CITY OF CAMBRIDGE  
BUILDING DIVISION

TITLE SHEET

BARLASSINA CONSTRUCTION

CITY OF CAMBRIDGE

BASEMENT PLAN EL-2  
BARLASSINA CONSTRUCTION  
CITY OF CAMBRIDGE

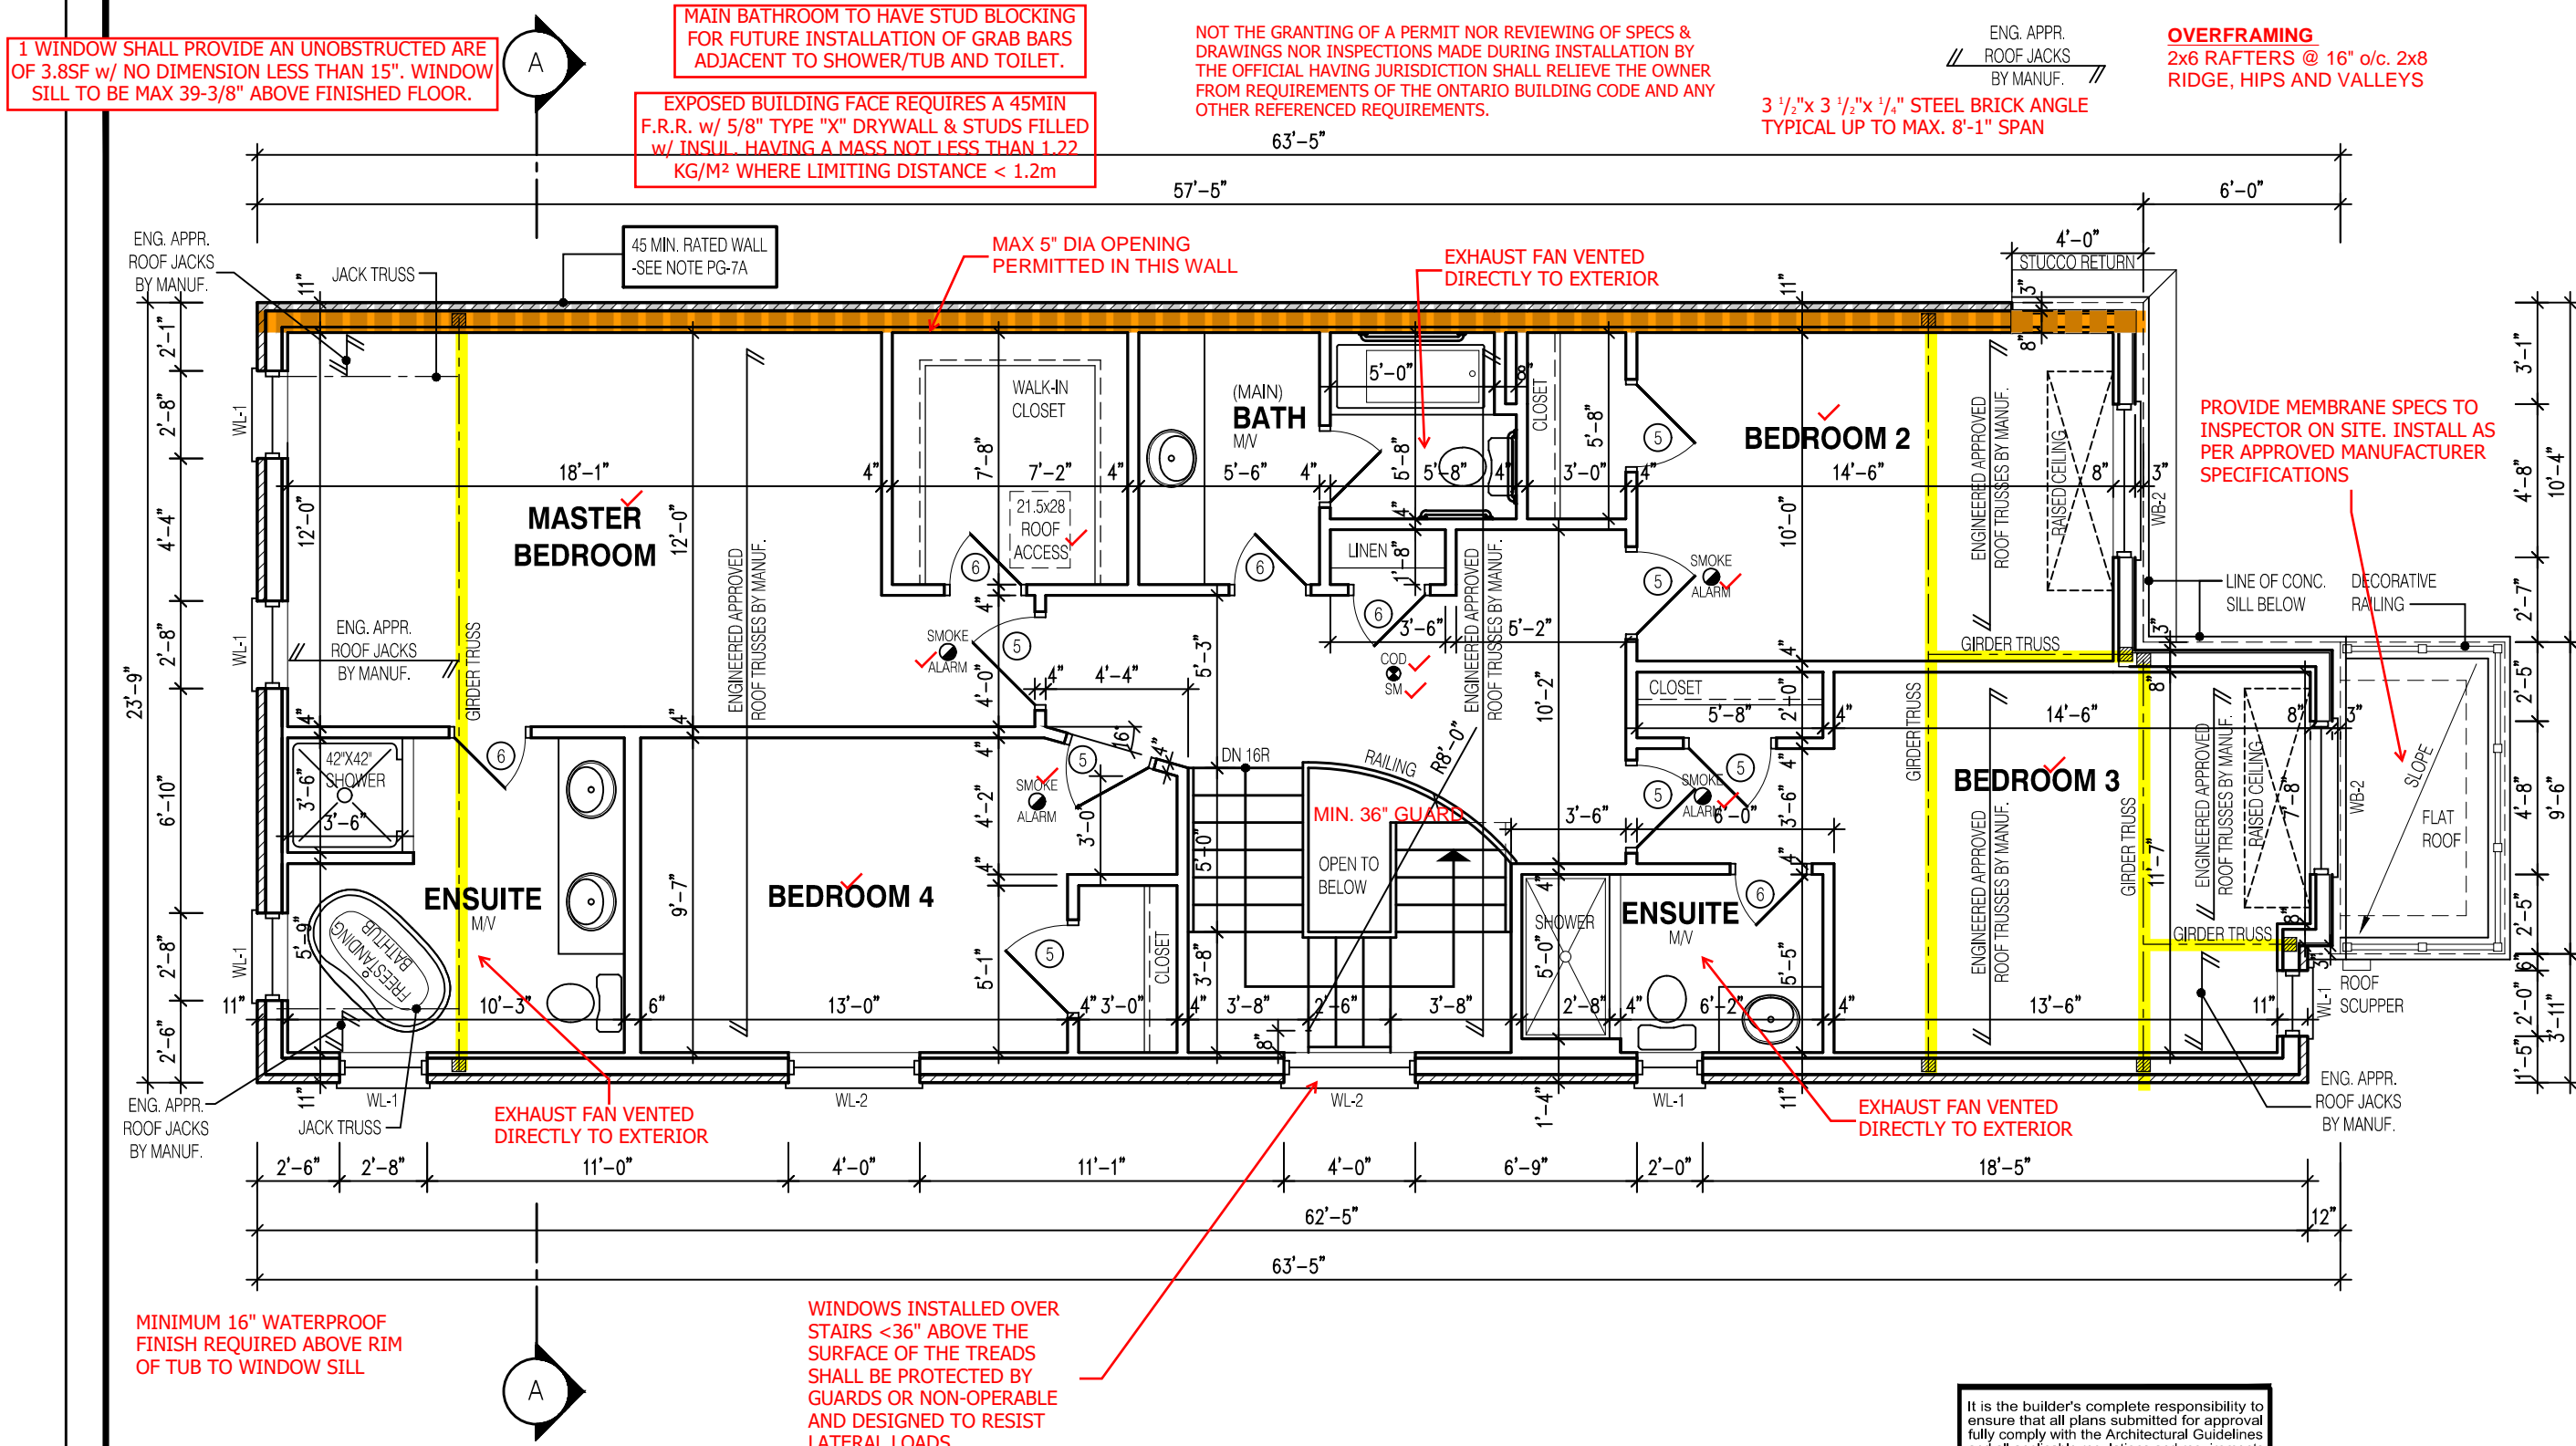
VERIFY WATER METER AND DWHR  
UNIT LOCATION WITH INSPECTOR

SPRAY FOAM/RIGID INSULATION TO BE  
PROTECTED AS PER 9.10.17.10.(1)

WATER METER TO BE INSTALLED WITHIN 2m  
(6'-6") FROM THE POINT THE WATER SERVICE  
PIPE MEETS THE BUILDING LINE

SEC. FLOOR PLAN EL-2  
BARLASSINA CONSTRUCTION  
CITY OF CAMBRIDGE

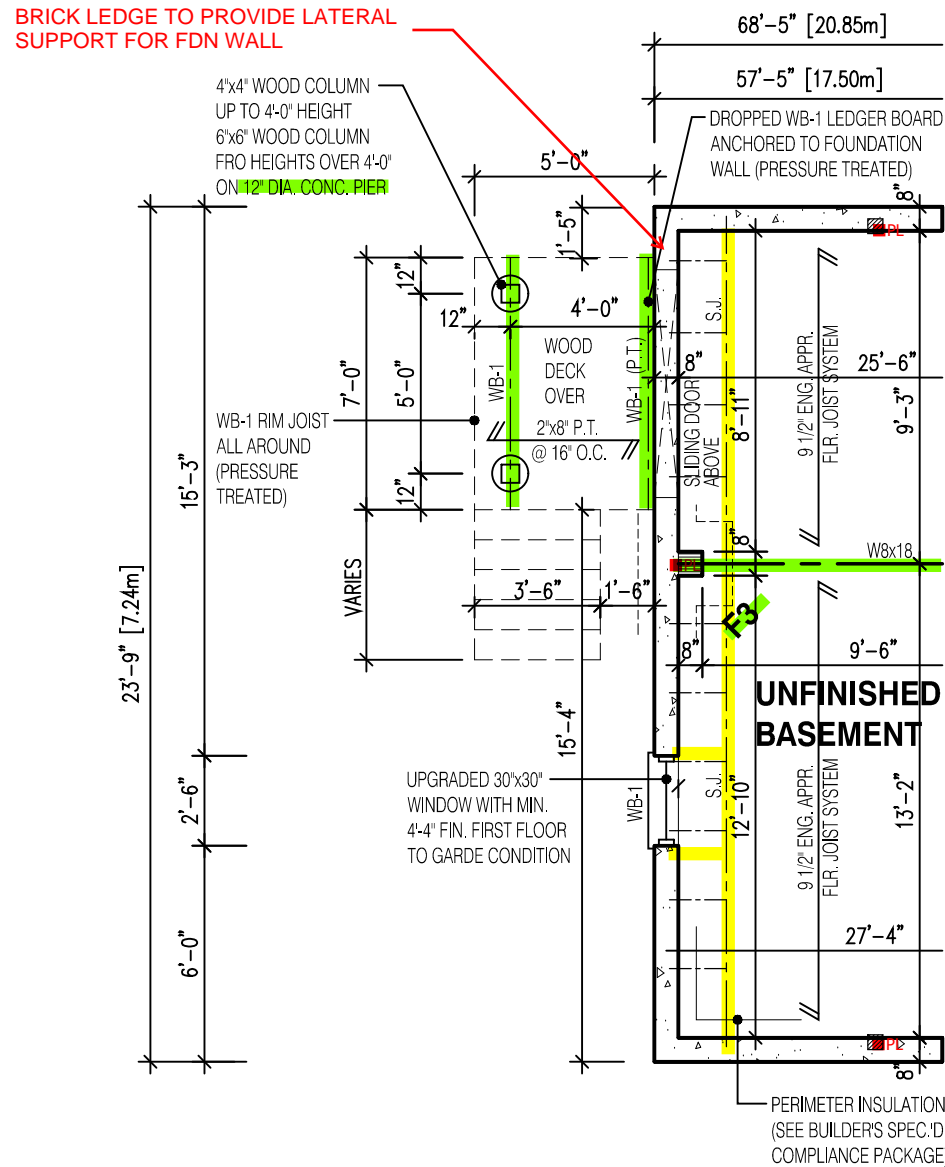
PROVIDE MEMBRANE SPECS TO INSPECTOR ON SITE. INSTALL AS PER APPROVED MANUFACTURER SPECIFICATIONS

MINIMUM 16" WATERPROOF FINISH REQUIRED ABOVE RIM OF TUB TO WINDOW SILL

WINDOWS INSTALLED OVER STAIRS <36" ABOVE THE SURFACE OF THE TREADS SHALL BE PROTECTED BY GUARDS OR NON-OPERABLE AND DESIGNED TO RESIST LATERAL LOADS

W.O.B. CONDITION EL-2  
BARLASSINA CONSTRUCTION  
CITY OF CAMBRIDGE

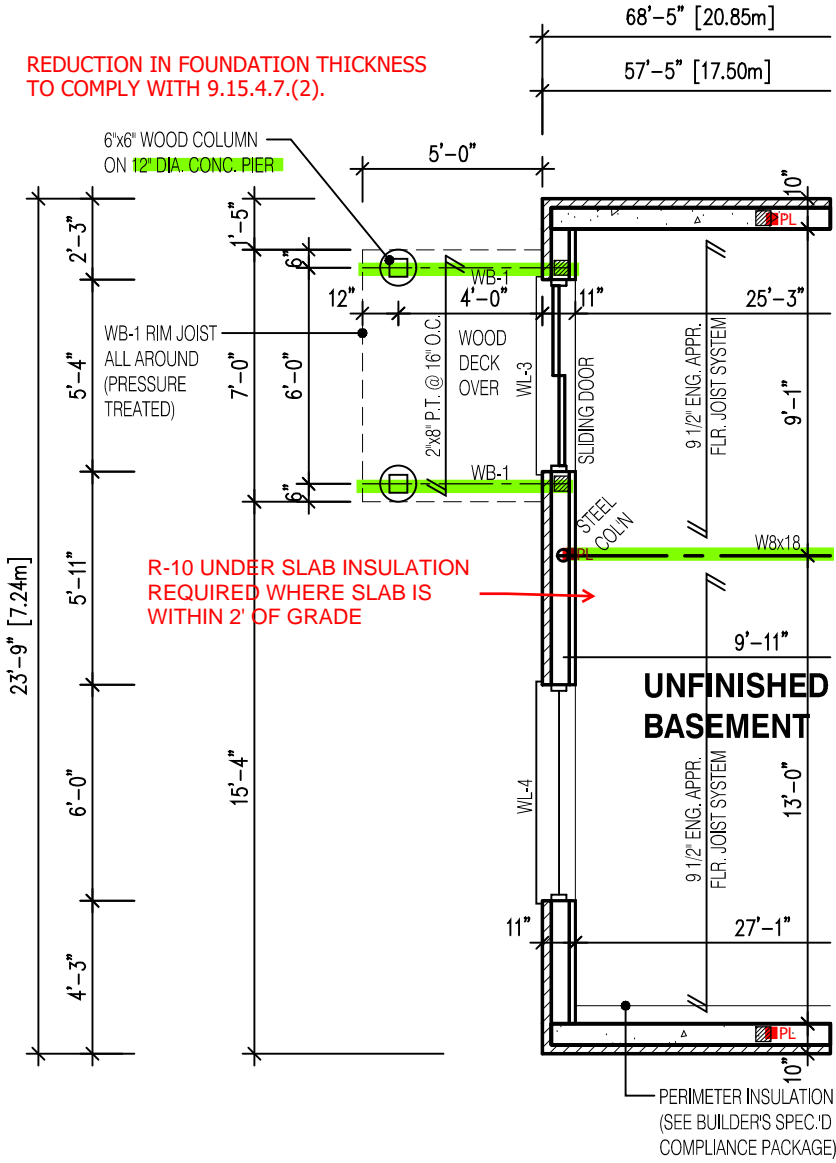
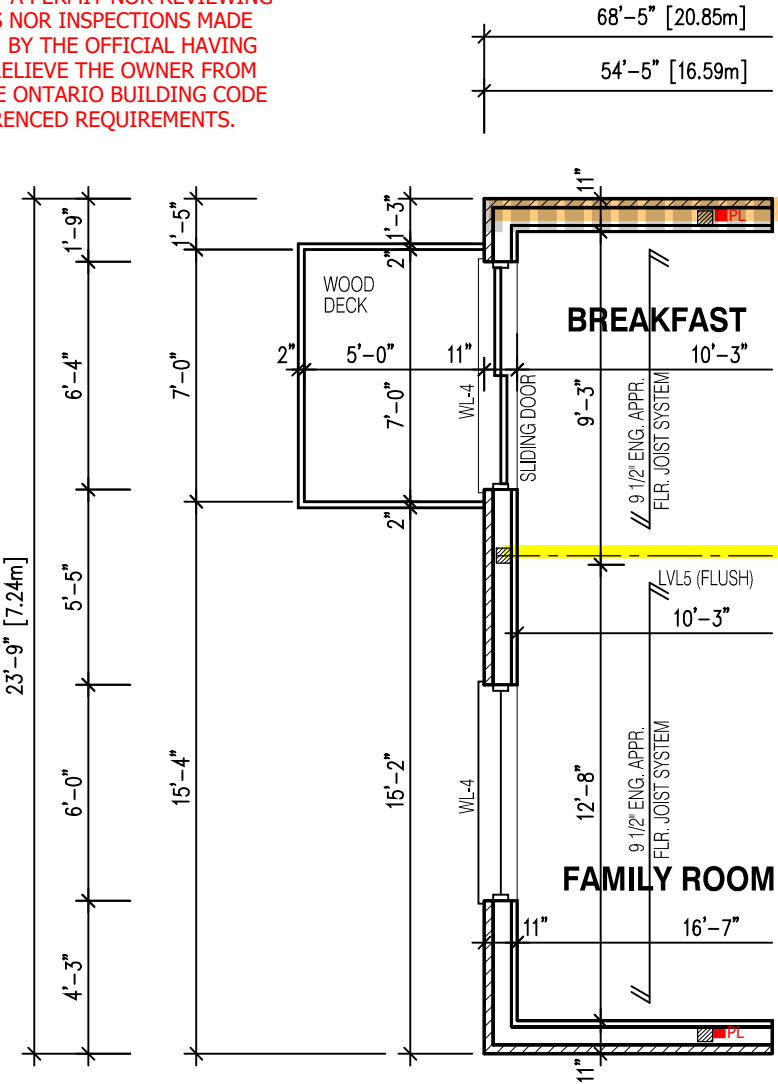
ALL GUARDS TO COMPLY WITH SB-7 OR P.ENG DESIGN. GUARDS TO BE MIN. 36" HIGH (900mm). WHERE DECK WALKING SURFACE TO FIN. GRADE EXCEEDS 5'-11" (1.8m), GUARD HEIGHT TO BE 42" HIGH (1.2m)

ENSURE P.ENG STAMPED RAILING DOCUMENTATION AND ATTACHMENT DETAILS ARE AVAILABLE FOR REVIEW BY THE INSPECTOR

GUARDS CONFORMING TO O.B.C. 9.8.8. & SB-7 ARE REQUIRED FOR PORCHES EXCEEDING 24" ABOVE GRADE.

## SECTION - B

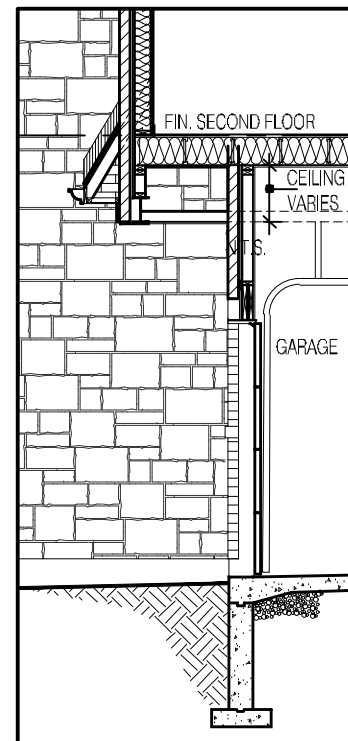
**A LIGHT IS REQUIRED AT ALL ENTRANCES  
TO A SINGLE FAMILY DWELLING**

STEP FOOTINGS. MAX 24"  
RISE. MIN 24" RUN

GUARDS CONFORMING TO O.B.C. 9.8.8.  
& SB-7 ARE REQUIRED FOR PORCHES  
EXCEEDING 24" ABOVE GRADE.

ENSURE P.ENG STAMPED RAILING  
DOCUMENTATION AND ATTACHMENT DETAILS  
ARE AVAILABLE FOR REVIEW BY THE INSPECTOR

EXTERIOR CONCRETE STAIRS w/ MORE  
THAN 2 RISERS TO MEET THE  
REQUIREMENTS OF 9.8.9.2.(1)

SIDE ELEVATION 2

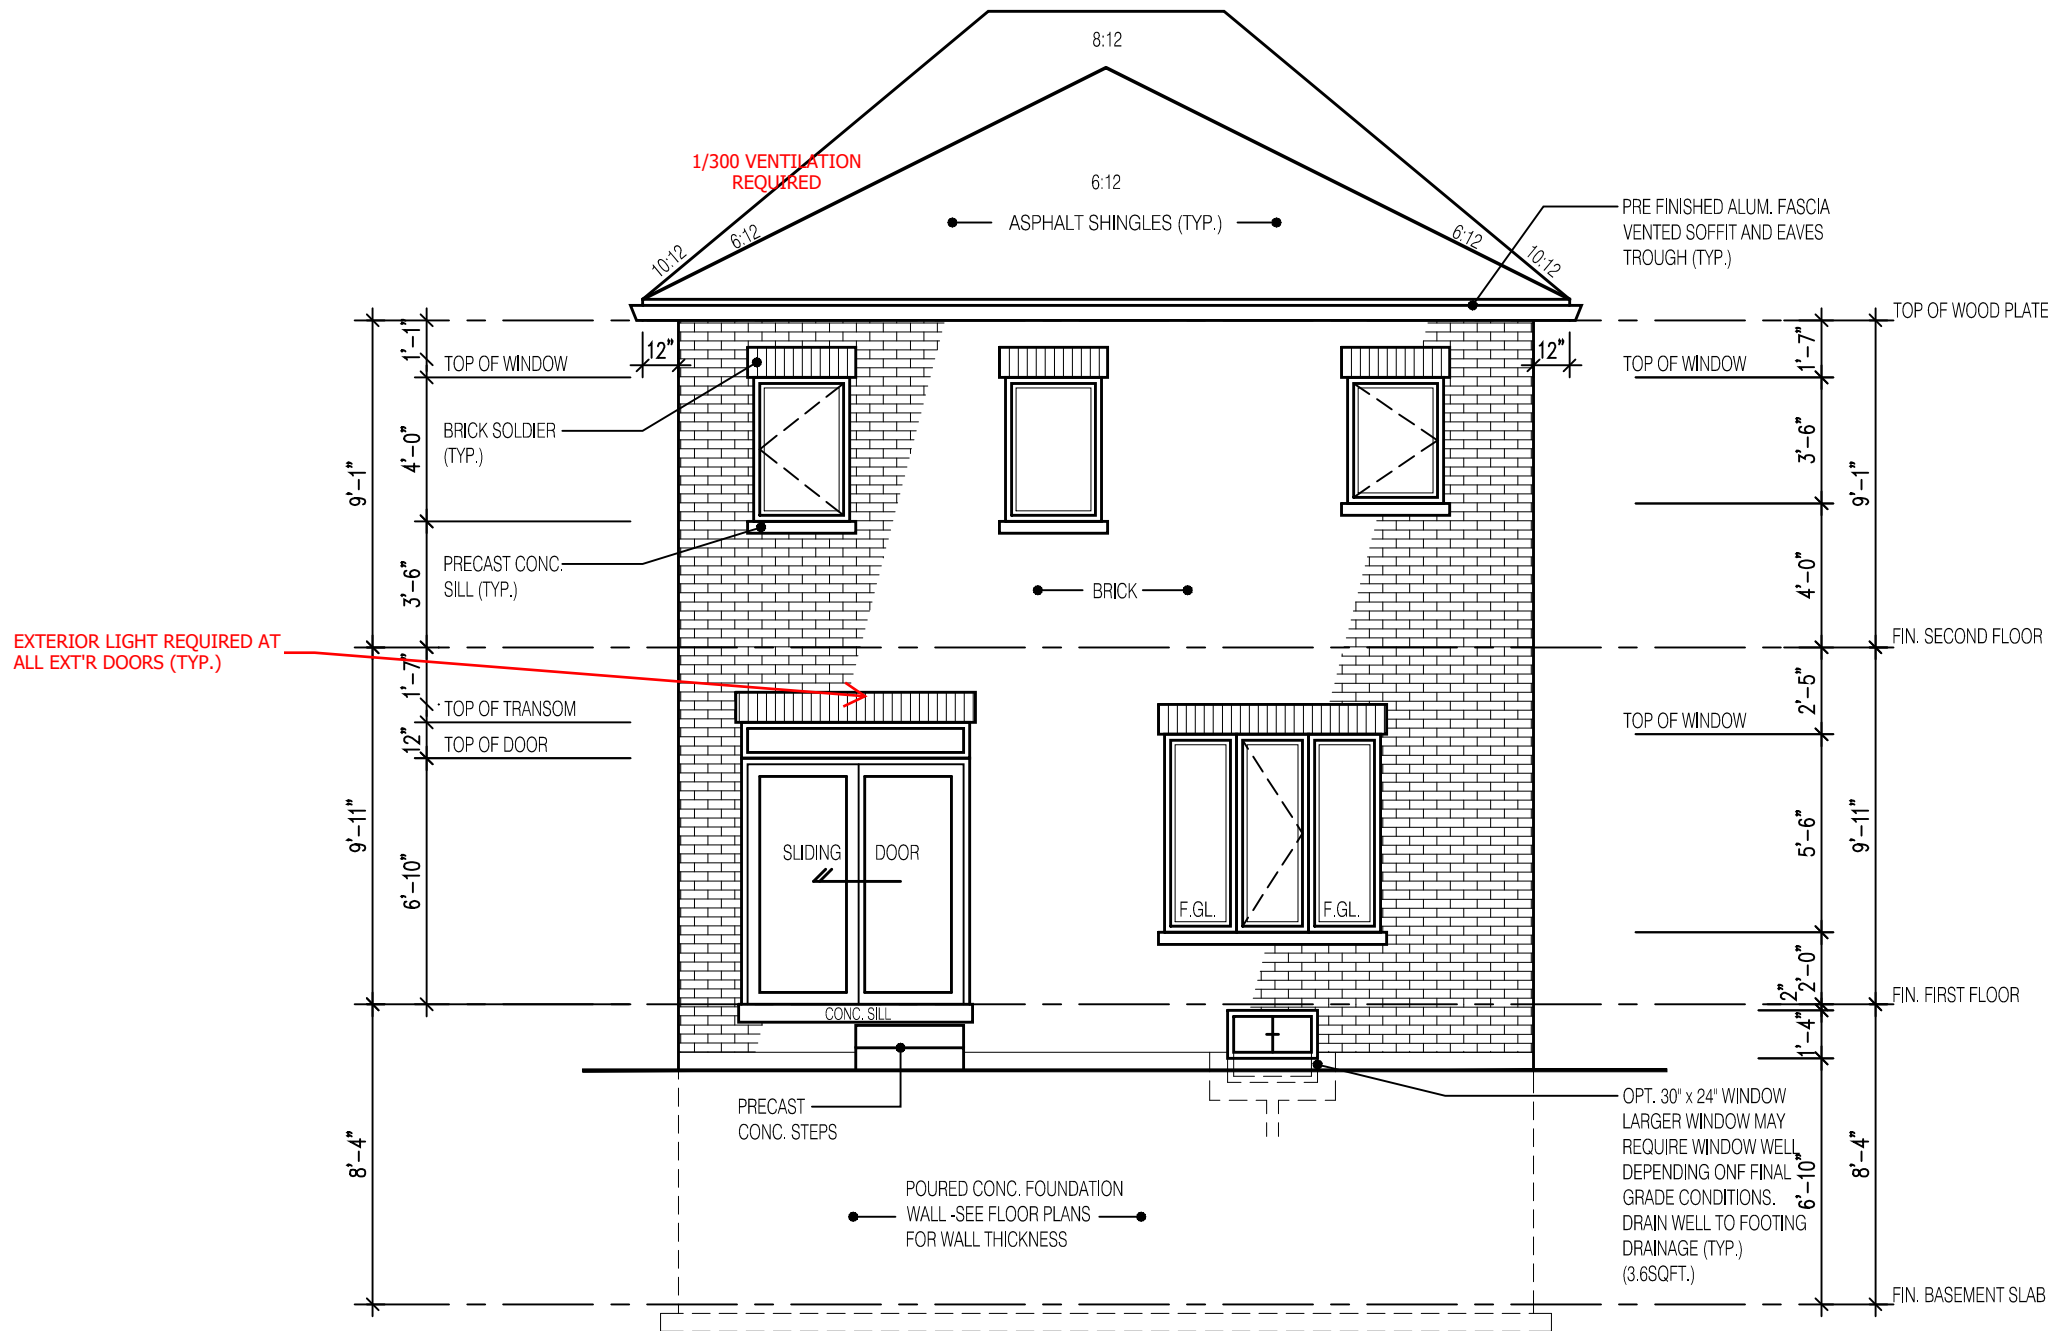
PROVIDE STAIR, GUARD AND LANDING OR  
INSTALL PERMANENT BLOCKING TO  
RESTRICT DOOR OPENING TO MAX. 4".
